Access Compliance Report

Public Rights-of-Way

(Curb Ramps)

Intersection ID: 9172	Main Street: E_CRAIGHEAD_RD	Cross Street: N_TRYON_ST	Location: SE
ADA ID: 48C7097F4AAA	Ramp Type: Perp	Initial Pass/Fail: Fail	Overall Compliance: No
Severity Score: 10			
Codes/Mitigation Info/Possible Solution		Field Measurements/Component Compliance

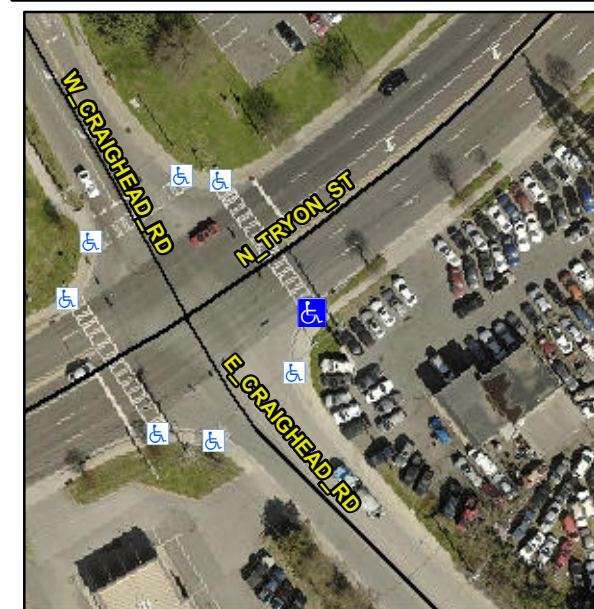
Not Found, R304.5.1, R304.5.3

Compliance	Description	Data	Compliance	Description	Data
N/A	Ramp Length (in)	106.5	Yes	Ramp Slope (%)	6.3
No	Ramp Width (in)	40.0	No	Ramp XSlope (%)	2.3
N/A	Flare Type LT	N/A	N/A	Flare Type RT	N/A
N/A	Flare Slope LT (%)	N/A	N/A	Flare Slope RT (%)	N/A
N/A	Flare Traversable LT?	N/A	N/A	Flare Traversable RT?	N/A
N/A	Landing Length (in)	N/A	N/A	DWS Provided?	N/A
N/A	Landing Width (in)	N/A	N/A	DWS Contrast?	N/A
N/A	Landing Slope (%)	N/A	N/A	DWS Length (in)	N/A
N/A	Landing X Slope (%)	N/A	N/A	DWS Full Width?	N/A
N/A	Landing Curb? (Y/N)	N/A	N/A	DWS Offset (in)	N/A
N/A	Shared Landing?	N/A			
N/A	Gutter Ponding?	N/A	N/A	Gutter Slope (%)	N/A
N/A	Gutter Lip Ht (in)	N/A	N/A	Gutter X Slope (%)	N/A
N/A	Painted X Walk1?	Yes	N/A	Painted X Walk2?	N/A
	X Walk 1 Direction	To N		X Walk 2 Direction	N/A
N/A	X Walk 1 Width (in)	88.0	N/A	X Walk 2 Width (in)	N/A
	X Walk 1 Slope (%)	2.4		X Walk 2 Slope (%)	N/A
	X Walk 1 X Slope (%)	1.2		X Walk 2 X Slope (%)	N/A

N/A	Ramp inside XWalk1?	Yes	N/A	Ramp inside XWalk2?	N/A
	Road Slope (%)	N/A	N/A	Clear Space?	N/A
	Road X Slope (%)	N/A	N/A	Clear Space to XWalk (in)	N/A
N/A	Any Obstructions?	N/A	N/A	Storm Grate/Utility Hazard?	N/A
	Obstruction Type			Storm Grate/Utility Type	
		N/A			N/A
		Yes		Surface Condition? (G/P)	Good

Remove & Replace Entire Ramp.
